| Model: Z-C1 Fax Option Type C400 | | Date: 05-Nov-12 | No.: RD483001 |
| Subject: G3 Decal Deletion | | Prepared by: T. Kiyohara | |

Service Manual Correction

D596 Service Manual

Fax Option Type C400 (D483-01/02/03)

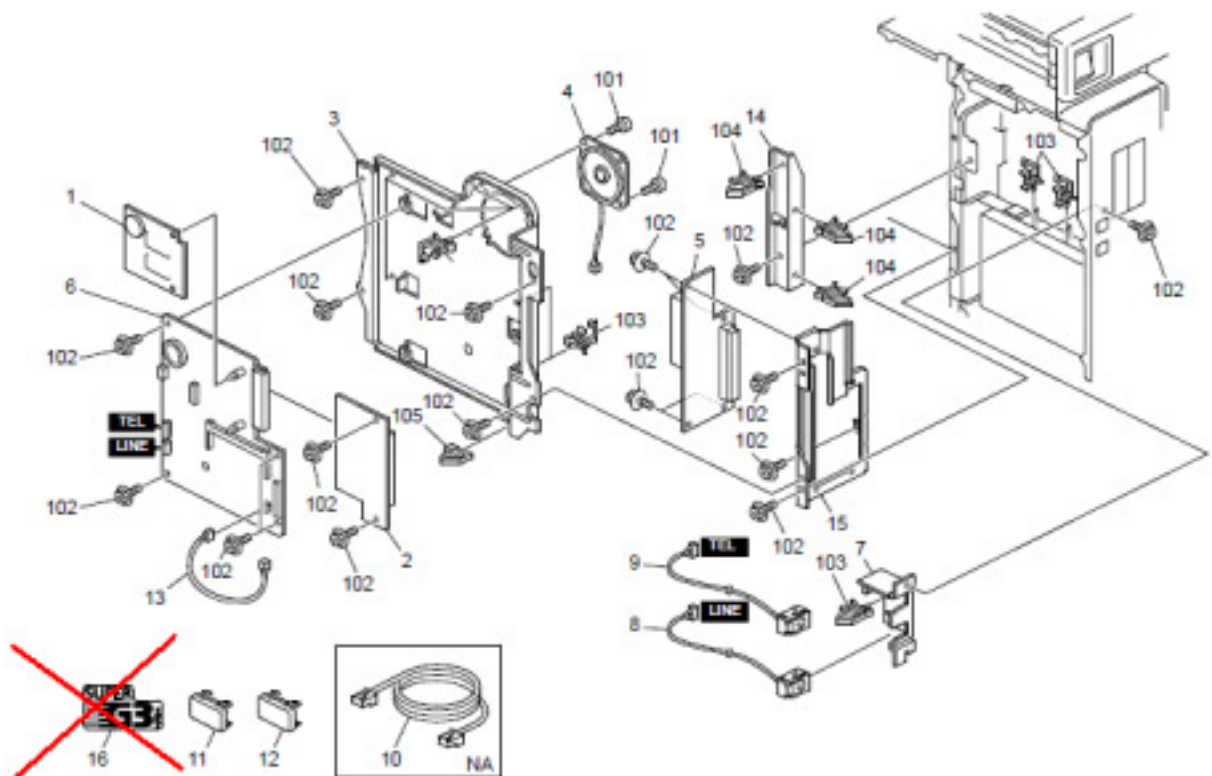
Note: These corrections were made because the G3 decal was deleted in September 2011.

Parts Catalog Correction

| Deleted Part Number | Description | Page | Index | Note |
|---------------------|-------------|------|-------|------|
| B4043861 | DECAL:SG3 | 3 | 16 | |
